NUMBER: B090R1133-0

SERVICE BULLETIN

Ride: ALL RIDES

Subject: FLOOD LIGHT SAFETY

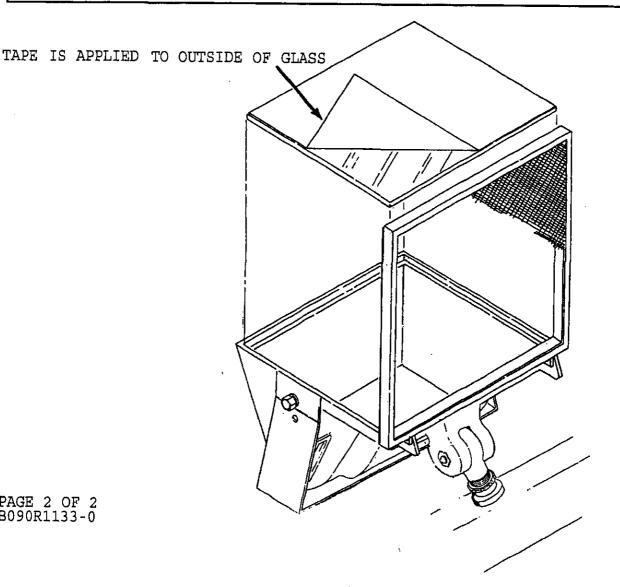
Chance Rides, Inc. now installs a special tape to the lens of the factory installed quartz flood lights used on amusement rides. This tape helps prevent the glass lens from falling apart even if it should break. This provides an additional measure of safety to personnel and passengers of the rides.

Chance Rides, Inc. requires all owner/operators of Chance Rides products with quartz flood lights to order and install tape, part number 45001700 as outlined in this bulletin. Tape comes in 10 inch width and is available by the foot. Order the appropriate amount, to the nearest foot, to insure all flood lights have been completely covered. This tape is available at no charge if ordered within 90 days of the date on this bulletin.

- Remove glass lens from light fixture.
- 2. Measure and trim tape to fit lens.
- Carefully remove the backing from the tape.
- Apply tape to glass in such a manner as to prevent air bubbles from forming.

A fine mist of water applied to the glass first may help eliminate air bubbles as well as increase the ease by which the tape is applied.

If water is used, make sure all water has evaporated from between the glass and the tape before turning light on. A period of at lease two days may be required for evaporation.
